Tallaght / Clondalkin to City Centre Core Bus Corridor Scheme

NTA Observations on the Proposed Scheme CPO Objections

September 2023

Figure 2.3.9: Existing and Proposed Layout at Fairfield Inns Limited property

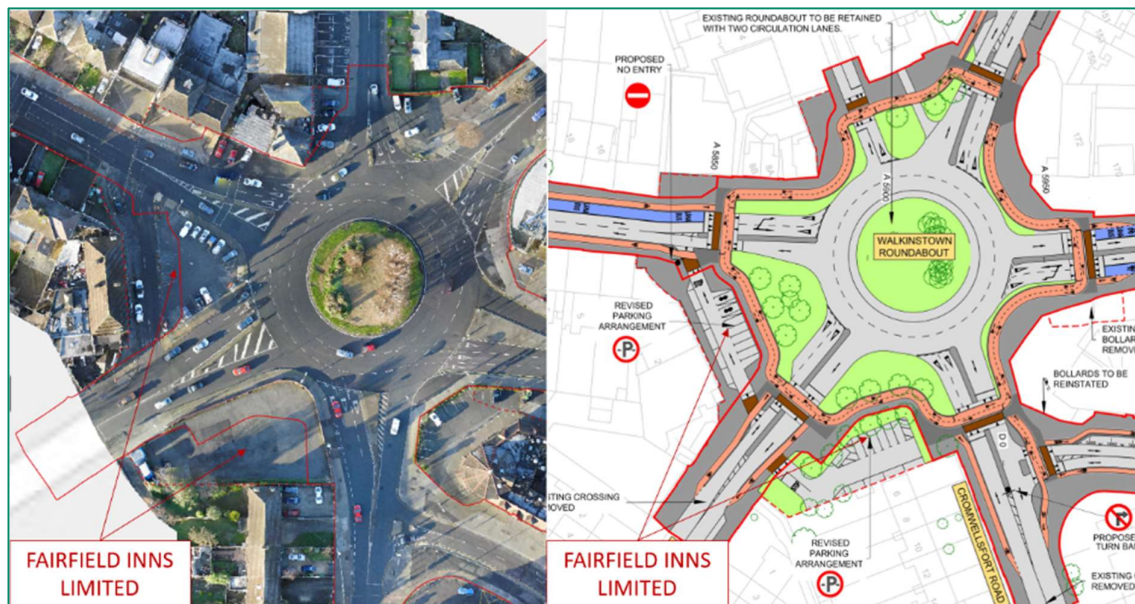
As shown in Figure 2.3.9, the permanent land acquisition is required from the two car parking areas to provide the two-way segregated cycle track that has been proposed around the junction. The route of the cycle tracks past the two car park areas has been aligned to allow a revised car parking arrangement to be designed within the remaining space.

Figure 2.3.12: Extract from Landscape General Arrangement Drawings at Walkinstown Roundabout (Sheet 19)

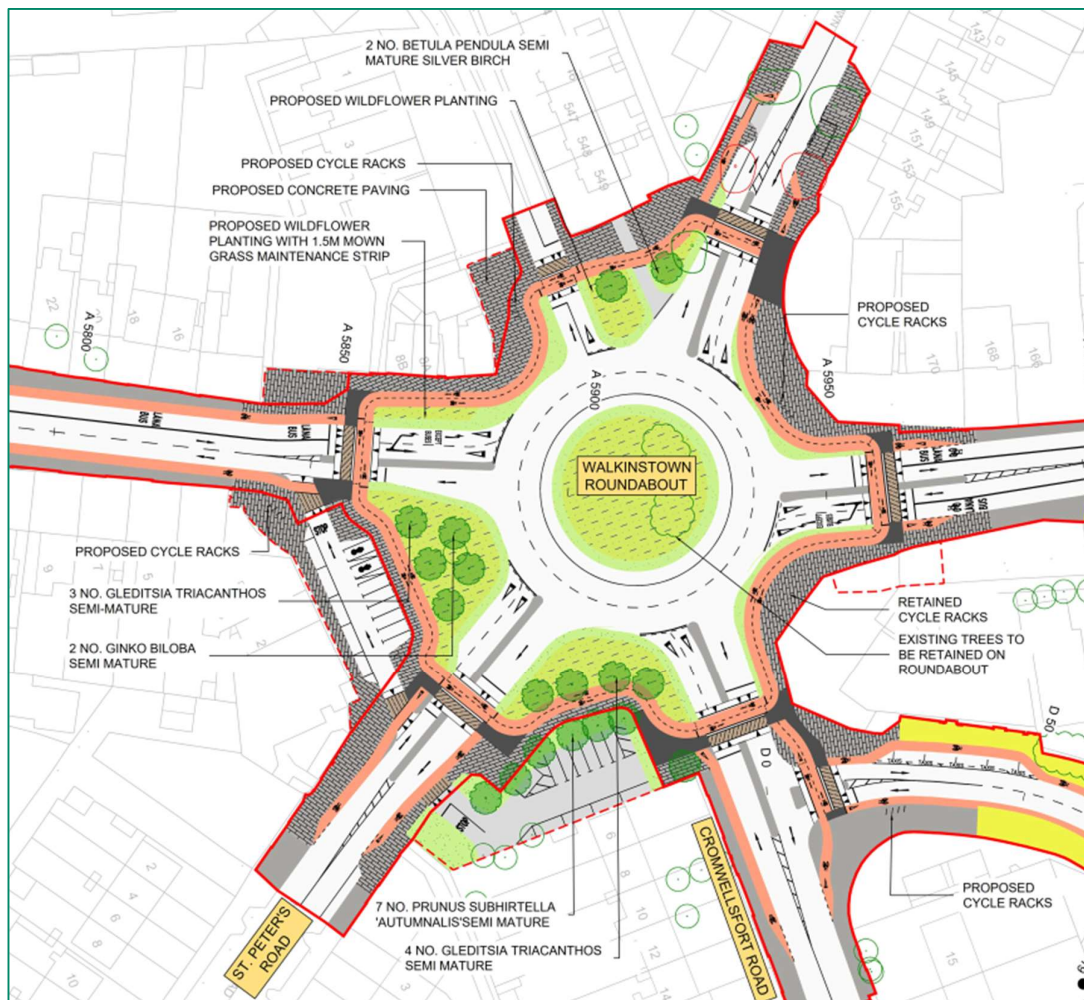
The relevant extract from the Landscape General Arrangement Drawings in the EIAR, Volume 3, Figures Part 1 of 3, Chapter 4 Proposed Scheme Description is shown in Figure 2.3.12.

Figure 2.4.6: Alternative Routes proposed (Image source: OpenStreetMap)

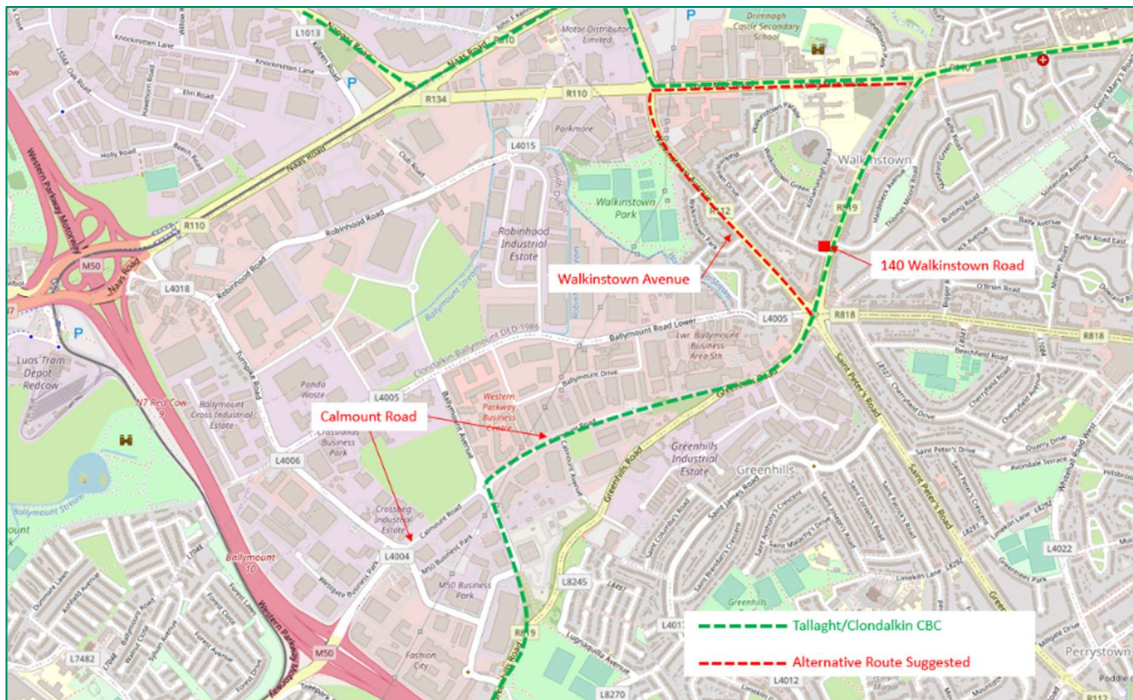
The submission does not provide any further details of these routes. Figure 2.4.6 shows the assumed alternative route along Walkinstown Avenue and Long Mile Road to Drimnagh Road. However, it is unclear where the alternative route along Calmount Road would be. As shown in Figure 2.4.6 the Proposed Scheme runs along Calmount Road and there is no direct route to the Long Mile Road. Therefore it is not possible to identify a clear route for this second suggested alternative route.

The alternative route along Walkinstown Avenue to the Long Mile Road suggested by the objection, which as shown in Figure 2.4.6 is routed along two sides of a triangle (north westwards along Walkinstown Avenue and then eastwards along Long Mile Road), was not included as one of the options identified as a potential route option that had the potential to meet the scheme objectives and was not included in the ‘spider’s web’ of route options.

Figure 2.7.2 Extract from Drawing of ST02 Naas Road Pedestrian and Cycle Bridge Plan Proposed, showing the curved ramp adjacent to Maxol LIMITED

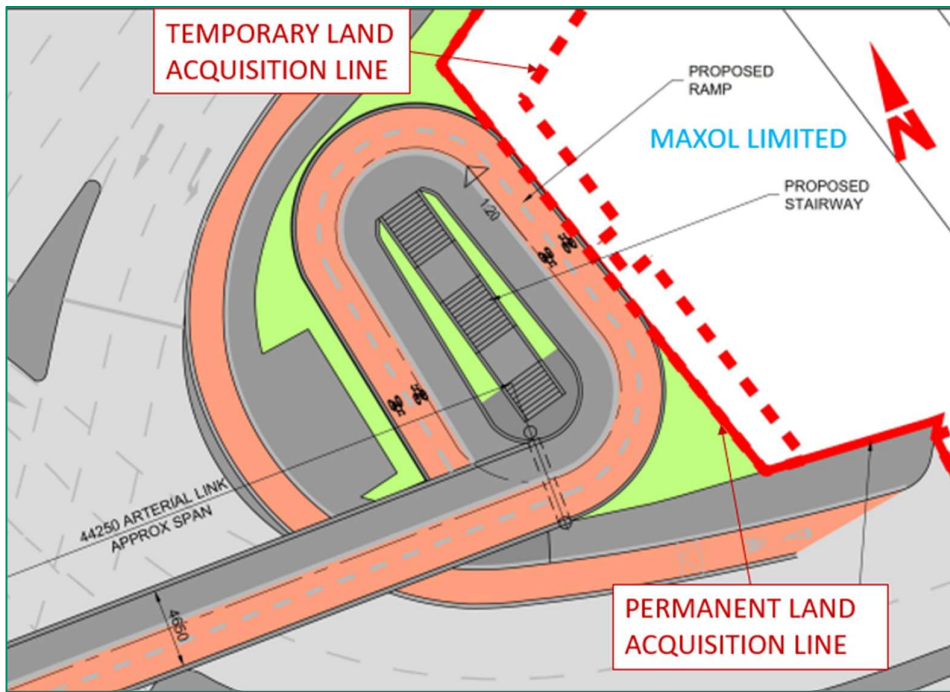
Details of the proposed bridges and associated ramps are shown on drawing BCIDA-ACM-STR_GA-0809_BR_00-DR-CB-0101 (ST02 Naas Road Pedestrian and Cycle Bridge Plan) as part of the Bridges and Major Retaining Structures drawings included in EIAR Volume 3 Part 2 of 3. An extract from this drawing is shown in Figure 2.7.2.

Figure 2.7.9 Proposed Land acquisition lines at the vent stack facilities

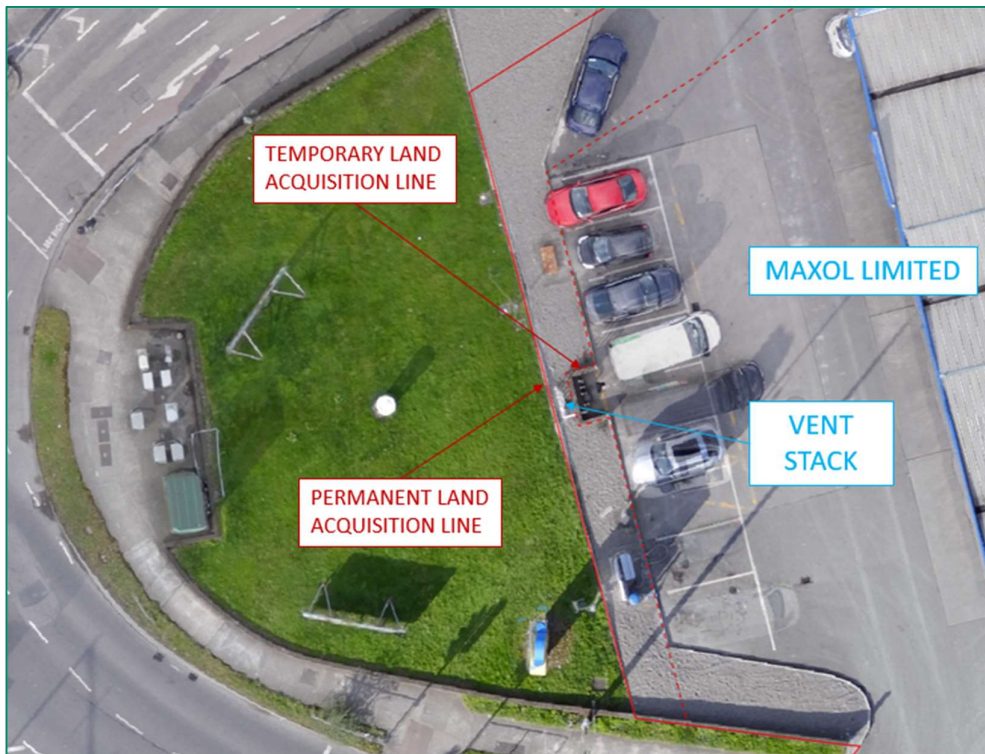
The proposed permanent and temporary land acquisition lines at these facilities are shown in Figure 2.7.9. This shows that the vent stacks and vapour recovery pipe are within the temporary land acquisition and the offset fuel delivery points are outside the proposed temporary landtake.

Figure 2.7.12 Extract from Proposed Scheme General Arrangement drawings showing proposed cycle track at Naas Road frontage (Image source: Google)

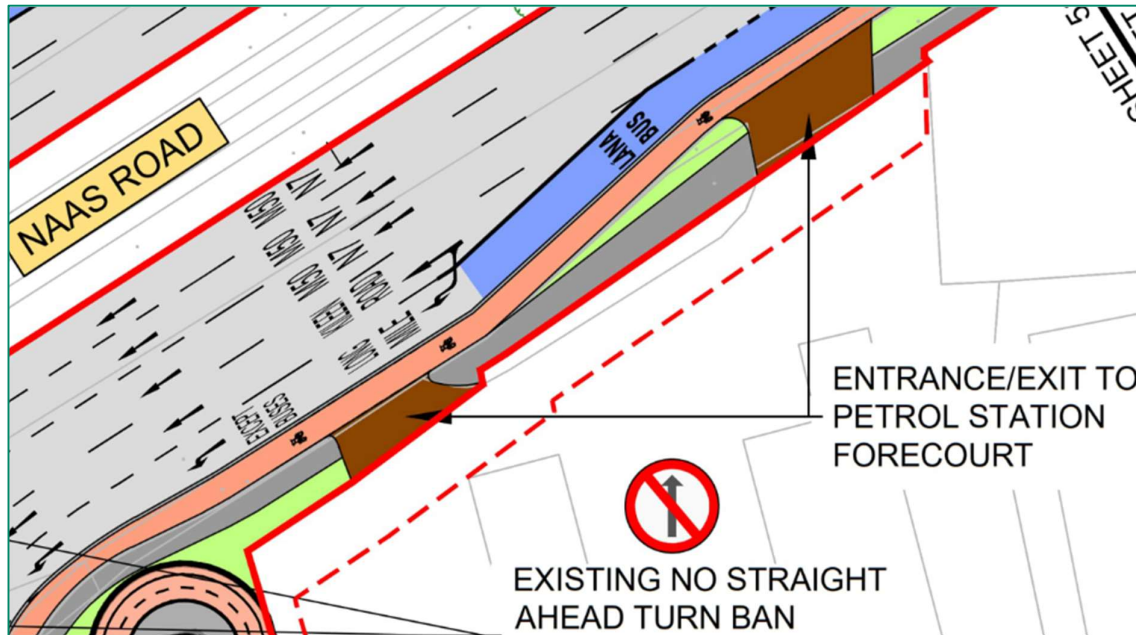
The relevant extract from the Proposed Scheme General Arrangement drawings is shown in Figure 2.7.12, which shows that while no changes are proposed to the general traffic lanes on the Naas Road, a segregated cycle track is proposed along this section of the route and this broadly follows the line of the existing footpath.

Figure 2.7.13 Proposed Land Acquisition lines overlain on aerial photography at Naas Road frontage

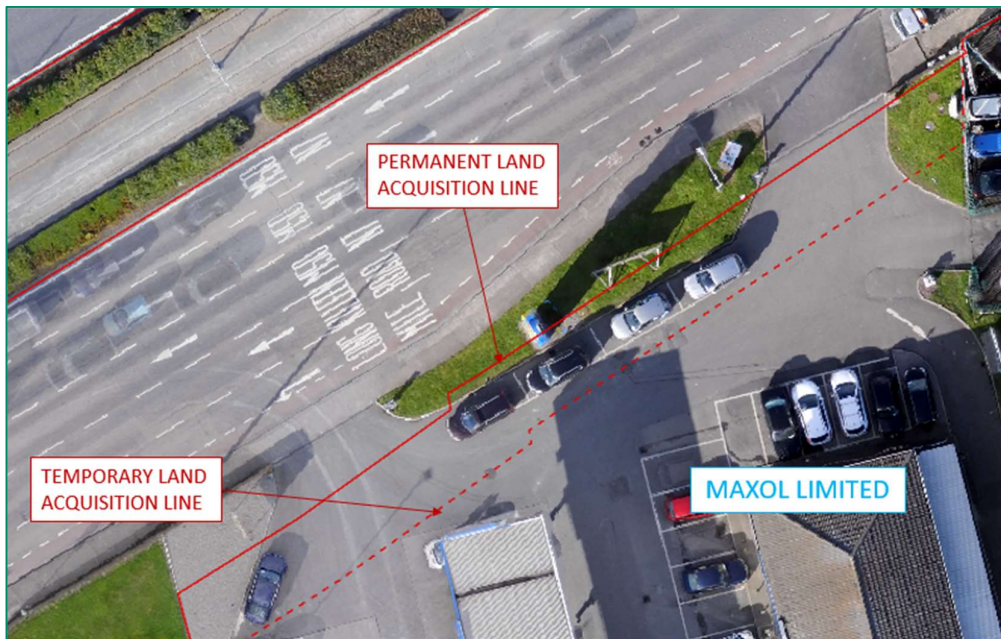
The proposed permanent and temporary land acquisition lines are shown in Figure 2.7.13. As can be seen some permanent land acquisition is required to provide the new footpath across the green area between the two access / egress points.

Figure 2.9.8: Alternative delivery proposal February 2022

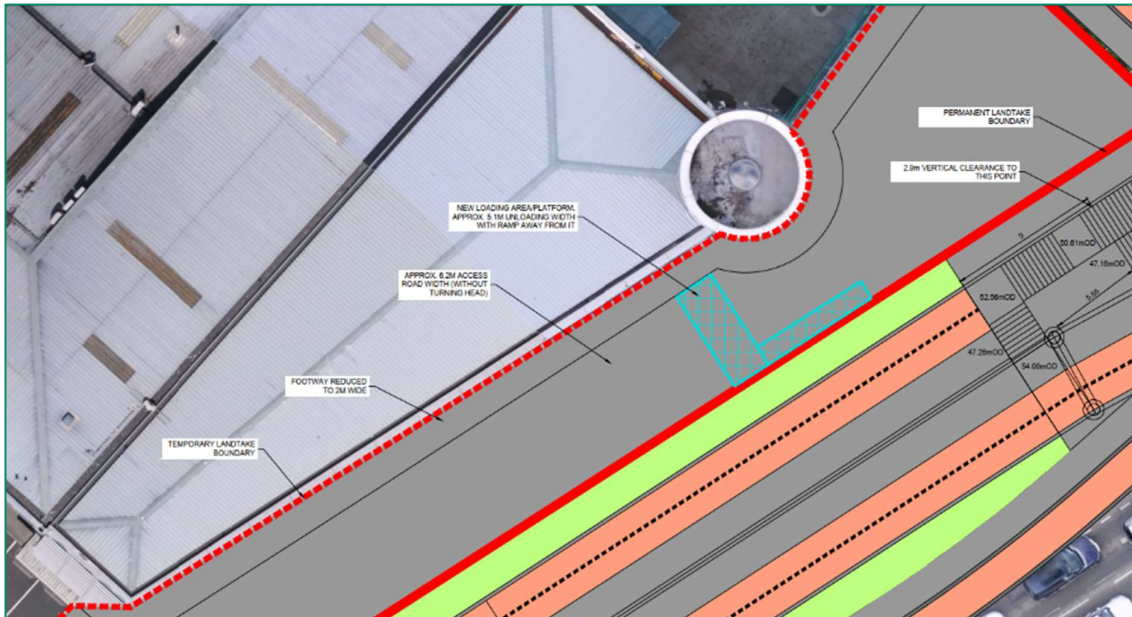
A drawing of these proposals was issued to Woodies DIY on 21 February 2022, as shown in Figure 2.9.8.

Figure 2.9.9: Alternative delivery proposals (Image source: Google)

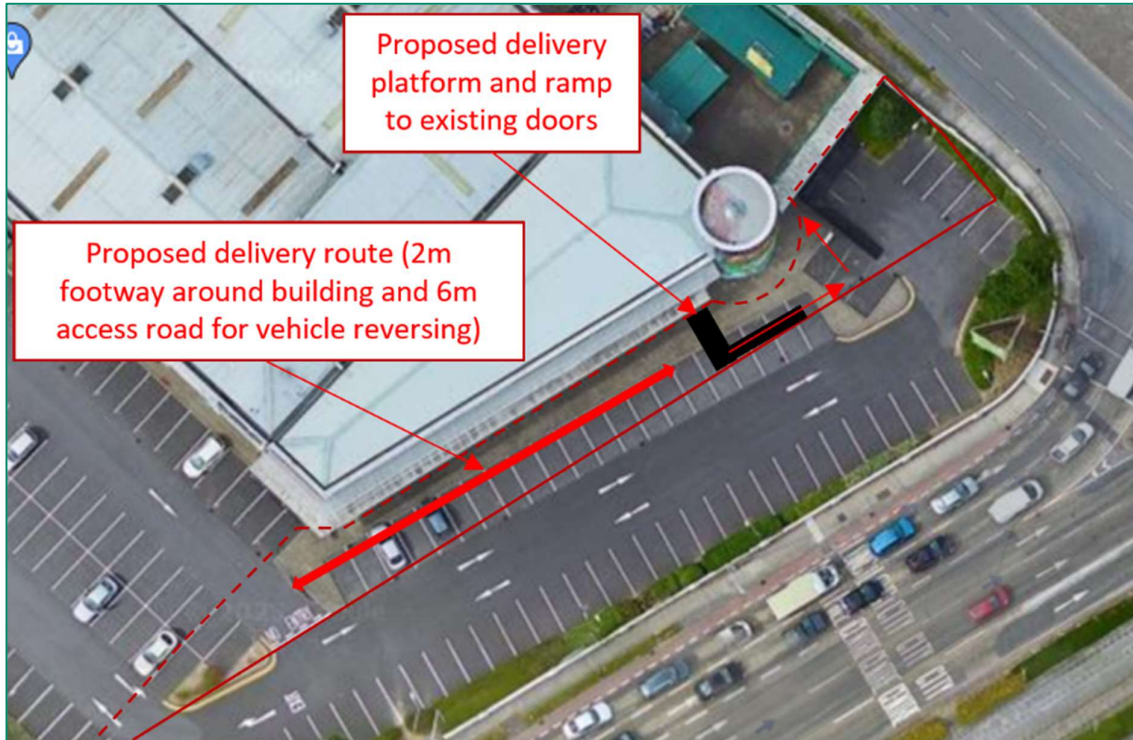
Figure 2.9.9 provides further clarity of the alternative delivery proposals.

Figure 2.9.10: Extract from General Arrangement drawings

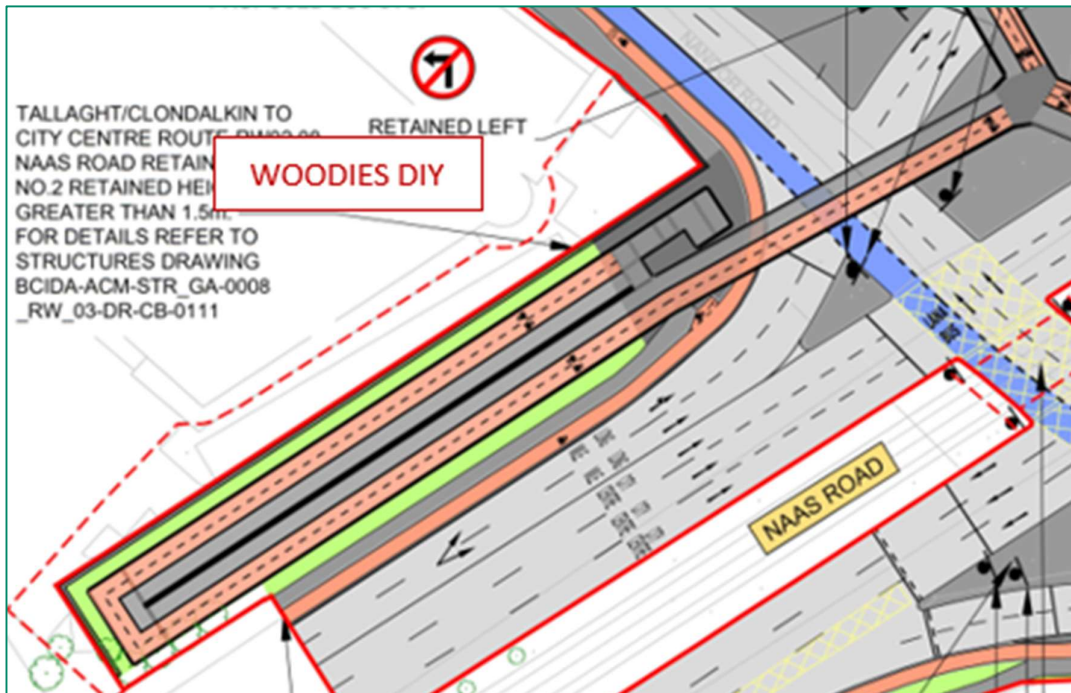
On three occasions the NTA endeavoured to have a further meeting with the representatives of Woodies DIY during 2022 but did not receive any responses to these requests. The alternative ramp layout and temporary land to facilitate the revised delivery arrangement have been incorporated into the Proposed Scheme, as shown in the relevant extract from the General Arrangement drawings included in EIAT Volume 3 Part 1 of 3 as shown in Figure 2.9.10.

Figure 2.9.15: Extract from General Arrangement drawings showing area with glazed panels avoided

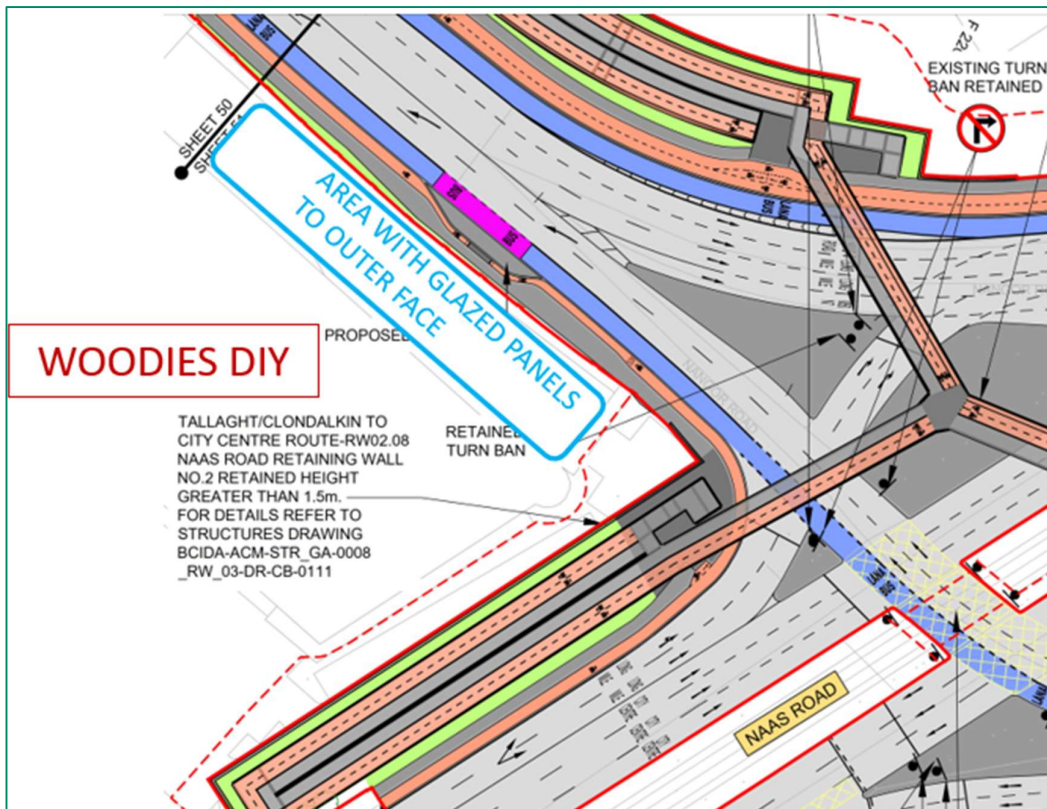
The NTA endeavoured to have a further meeting with the representatives of Woodies DIY during 2022 but did not receive any responses to these requests. The alternative ramp layout and temporary land to avoid any direct impact on the glazed panels have been incorporated into the Proposed Scheme, as shown in the relevant extract from the General Arrangement drawings included in EIAT Volume 3 Part 1 of 3 as shown in Figure 2.9.15.

Figure 2.9.17 Location of glazed panels at Woodies DIY (Image source: Google)

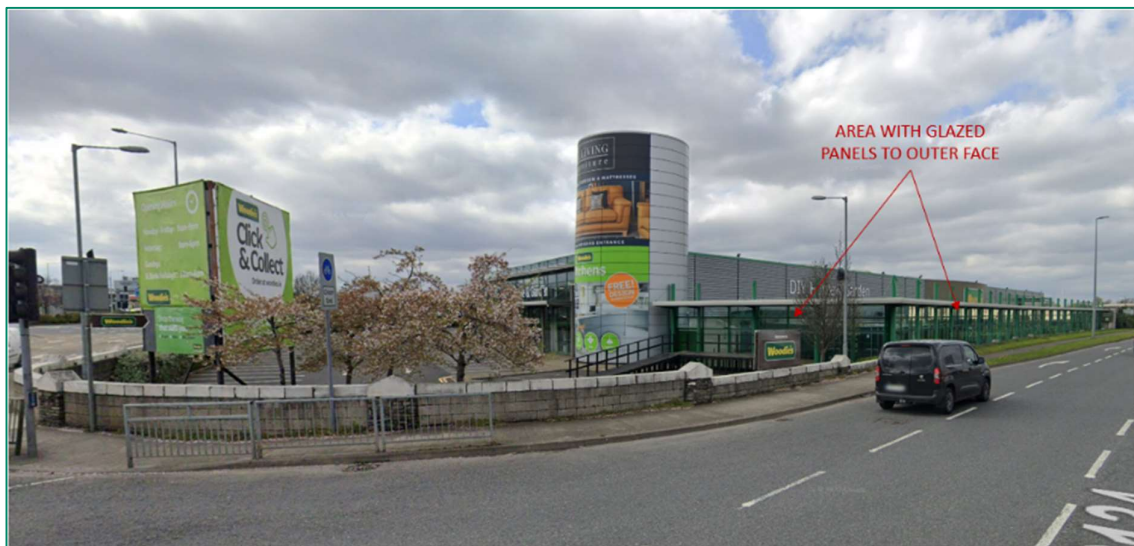
Figure 2.9.17 shows the view of Woodies DIY from the New Nangor Road with the glazed panels highlighted.

As shown in Figure 2.9.17, a retaining wall (Reference RW05) is proposed along the new boundary which will replicate the existing boundary treatment along the Naas Road. The ramp is proposed to commence at existing ground level at the point closest to the glazed panels and increases in height westwards before u-turning and increasing in height to meet the proposed bridge across the adjacent road junction. At the commencement of the bridge the ramp will be approximately 18.5m from the edge of the glazed panels.
